INDESIT company

Model type:
IDL75SEU

Commercial code:
F030604

N1045072FIG1

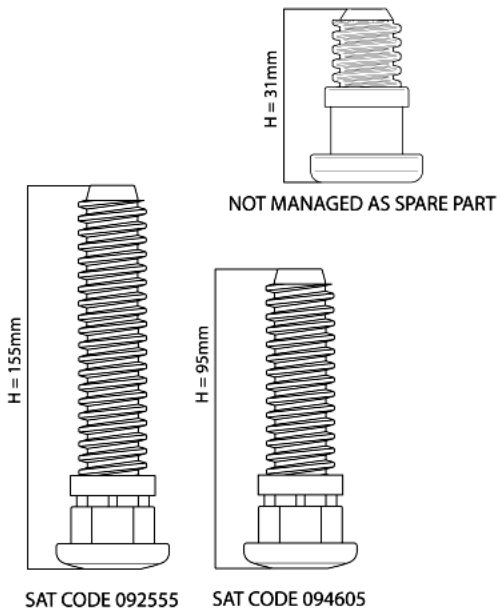
N1045072: Introduction of fixed rear foot H=31mm on free-standing models.

From serial no. 40218.0001, free-standing dishwashers affected by this modification have been equipped with new fixed rear feet (H=31mm).
The new foot replaces the adjustable one (H=155mm) Service code 092555; on the EVO3 range with TurboDry the new foot replaces the adjustable foot (H=95mm) Service code 094605.
The Spare Part Warehouse will continue to manage only 155mm and 95mm adjustable feet as they are interchangeable with the fixed 31mm foot.
The three feet are shown in illustration N1045072FIG1.

N1045080FIG1

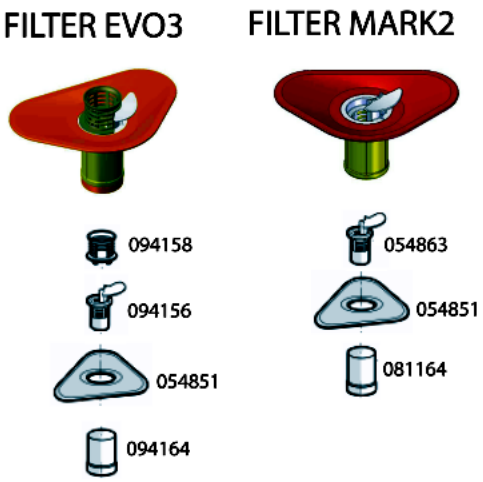
n1045083: Modification of filters on EVO3 60 cm dishwashers

All dishwasher models affected by this modification have been equipped with the items listed below, in order to solve the drain pump clooging problem.

Introduction of:
Cylindrical plastic filter code 081164
Central filter code 054863

Elimination of:
Cylindrical plastic filter code 094164
Central filter code 094156
Central filter grid code 094158

The modification has been introduced progressively, starting from serial no. 40516.0001.

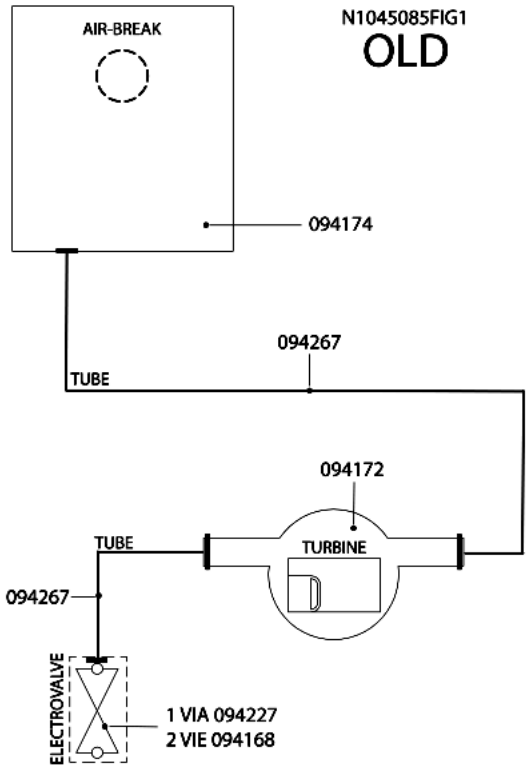
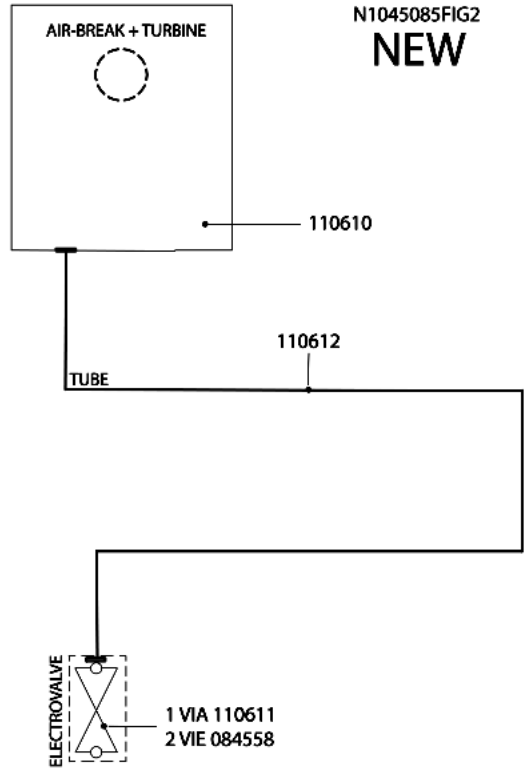
n1045085: Introduction of new litre counter turbine integrated on air-break.

All dishwashers affected by this note have been equipped with a new litre counter turbine on the air-break.
Picture N1045085FIG1 illustrates the premodification structure, picture N1045085FIG2 the new structure.

Items affected by the modification.

AIR-BREAK:
new 110610;
premodification 094174;
the new item features a new integrated litre counter turbine and its water supply hose has a smaller diameter.

LITRE COUNTER TURBINE code 094172 has been eliminated.

SOLENOID VALVES:
new:
1-WAY code 110611;
2-WAY code 084558(Rohs 143737);
premodification:
1-WAY code 094227;
2-WAY code 094168;
the new solenoid valves have a smaller diameter drain hose fitting.

HOSES:
new solenoid valve hose/air-break code 110612;
premodification turbine hose/air-break code 094267;
premodification solenoid valve hose/air-break code 094267;
the new hose has a smaller internal diameter.

WIRING:
the litre counter turbine connecting cable is longer, but since the connector is the same, the new item can be used in place of the premodification one.
